PATENT Ullalor

For: FAN APPARATUS FOR CHAMBER OF HANDLER

PETITION TO WITHDRAW HOLDING OF ABANDONMENT

REPLY AND/OR AMENDMENT UNDER 37 C.F.R. §§1.111 AND/OR 1.121

FIG. 4

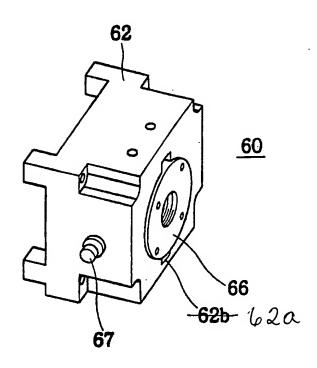
The Examiner is requested to review and approve the changes made to Figure 4 as shown in the enclosed markup. A corrected formal version of Figure 4 is also enclosed.

The Office Action objects to the drawings as failing to comply with 37 C.F.R. 1.84(p)(5). The specification has been amended at page 2, line 27 to indicate that the sensor dog and sensor brake are not shown in Figure 1. Further, Figure 4 is corrected to properly indicate a feature corresponding to reference numeral 62a. Accordingly, it is respectfully submitted that the drawings meet the requirements of 37 C.F.R. 1.84(p)(5), and thus the objection should be withdrawn.

Application No. 10/058,385 Amendment Dated October 14, 2003 Reply to Office Action of April 14, 2003 Annotated Sheet Showing Changes
